DOCUMENTATION TRANSMITTAL

Documentation Description: Nonconformance Reports - C-00960 & C-02005-HV

NONCONFORMANCE REPORT

NONCONFORMANCE REPORT

MARK NO. 17-004-16-11									
NO. 17-004-16-11									
SHEET 1 OF 1									
REV 0

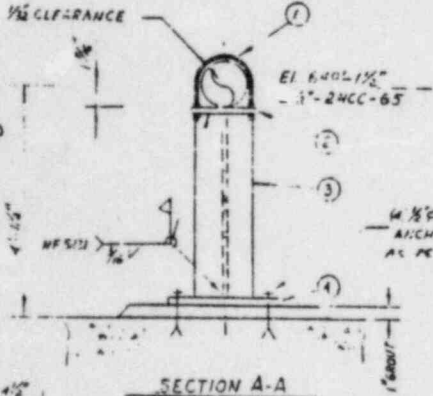
- (1) ITEM 2-3 WELD NORTH EAST CORNER HAS POROSITY $> \frac{1}{16}$ "
(2) MATERIAL TYPE INDETERMINATE DUE TO NO METHOD OF TRACING CODES ON BOLTING MATERIAL TO A MATERIAL SPEC. AND GRADE. CODE ON U-BOLT IS H-1715 M-79 QM 3-28-84
(3) MATERIAL TYPE INDETERMINATE DUE TO NO METHOD OF TRACING CODES ON BOLTING MATERIAL TO A MATERIAL SPEC. AND GRADE. CODE ON U-BOLT IS H-1715 M-79 QM 3-28-84
SEE CONTINUATION SHEET

3) SOUTH EAST ANCHOR BOLT HAS $7\frac{1}{16}$ " GOUGE MARK.

4) BOLTS ~~APPEARED~~ TO HAVE BEEN CUT ^{OR GRINDED M 19 ON 8-27-84} BEYOND THE CHAMFERED ENDS, MAKING THIS ACTIVITY INDETERMINATE.

5) U.T. REPORT NUMBERS 11842 AND 130582 HAVE DIFFERENT THICKNESS RECORDED ON THE TWO REPORTS. UT REPORT # 130582 CALLS FOR SOUTH WEST ANCHOR BOLT TO BE $6\frac{3}{4}$ " LONG. ATTACH. 7 PAGE 1 DOES NOT IDENTIFY ANY $\frac{1}{2}$ " ANCHOR BOLTS TO BE THAT LENGTH.
